**SITE:** Land adjacent to Lewis Way, Peterchurch, Herefordshire  
**TYPE:** Planning Permission  
**DESCRIPTION:** The erection of 25 no. dwellings and associated works including the creation of a new access, open space, landscaping, and drainage infrastructure.  
**APPLICATION NO:** 232431  
**GRID REFERENCE:** OS 334471 - 238906  
**APPLICANT:** Mrs E Morgan & Messrs G & D Morgan  
**AGENT:** Matt Tompkins

Our knowledge of the development proposals has been obtained from the additional sources provided following our previous consultation responses in September 2023, January 2024 and November 2024:

- Drainage Letter – January 2025.

Figure 1: Environment Agency Flood Map for Planning (Rivers and Sea), September 2023.

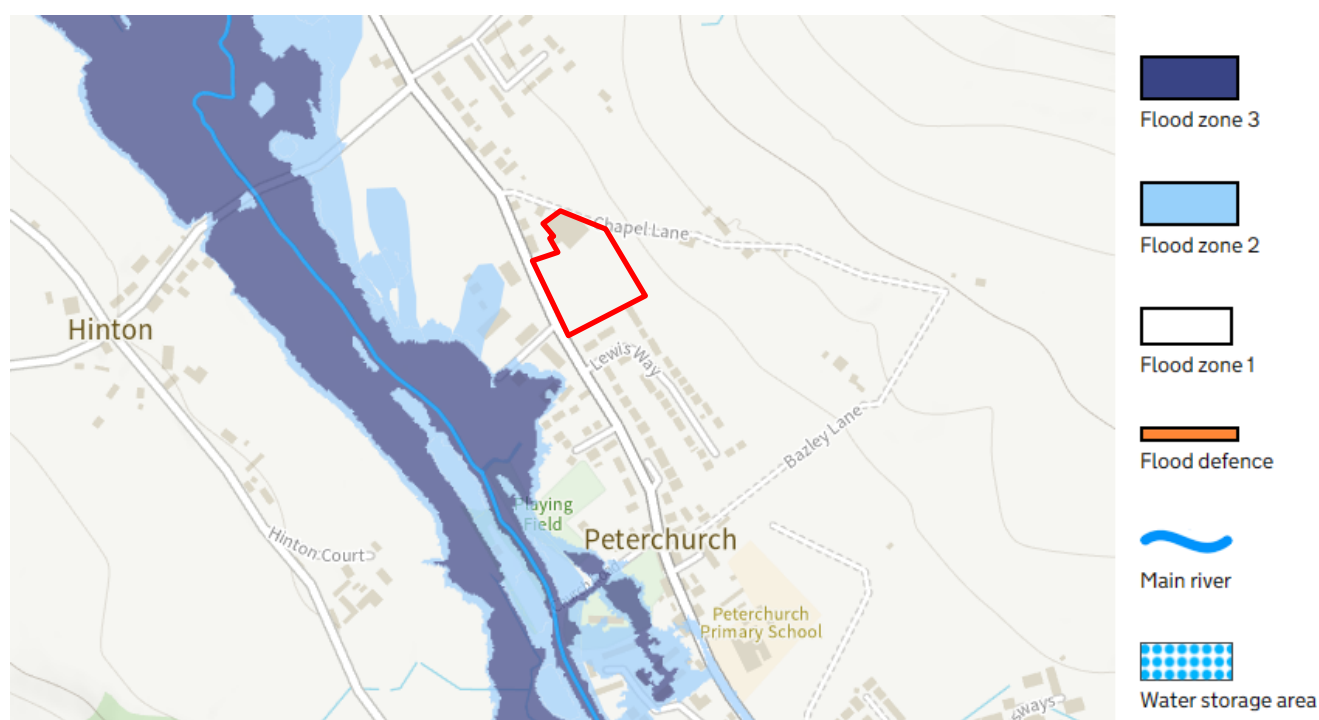
Review of the Environment Agency's Flood Map for Planning (Figure 1) indicates that the site is located within the low probability Flood Zone 1.

Loss of use of car park spaces due to tank collapse

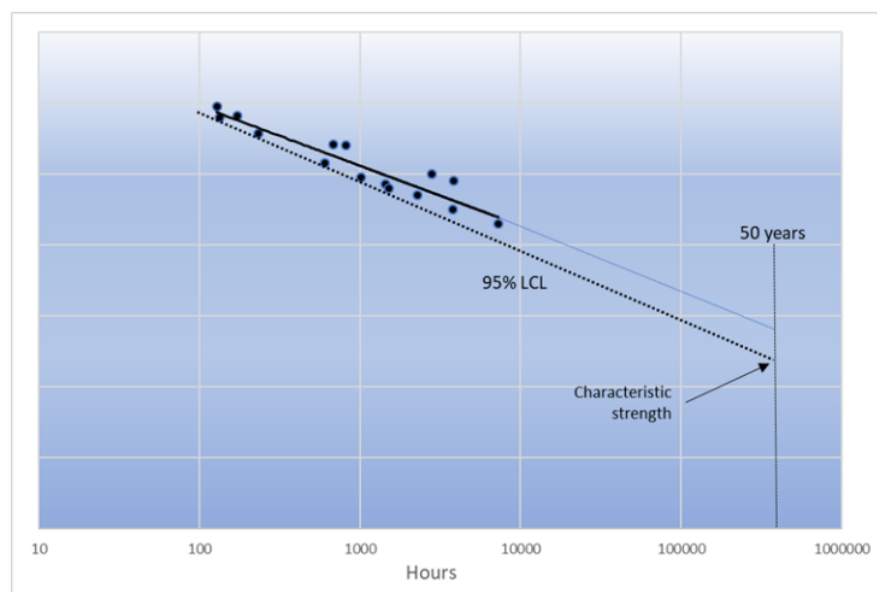
Our initial commentary (28<sup>th</sup> September) highlighted the risk that a collapse of the geocellular crates could occur (refer to the image below). The system layout should be designed so that, should this occur, access to the development would not be inhibited. Furthermore, access for future maintenance of the infrastructure will compromise access to the development.

Our original concern was that if the geocellular crate is installed below the site access road, it may collapse, restricting access to property. This would not only cause a nuisance to residents but would also prevent emergency access.

We do not object to the use of geocellular crates, but due to the risks of access to Emergencies it is not appropriate to install them below highways. If a solution utilising crates was presented along with off-site measures to mitigate the impact of pollution of the River Dore, then we may support such a proposal
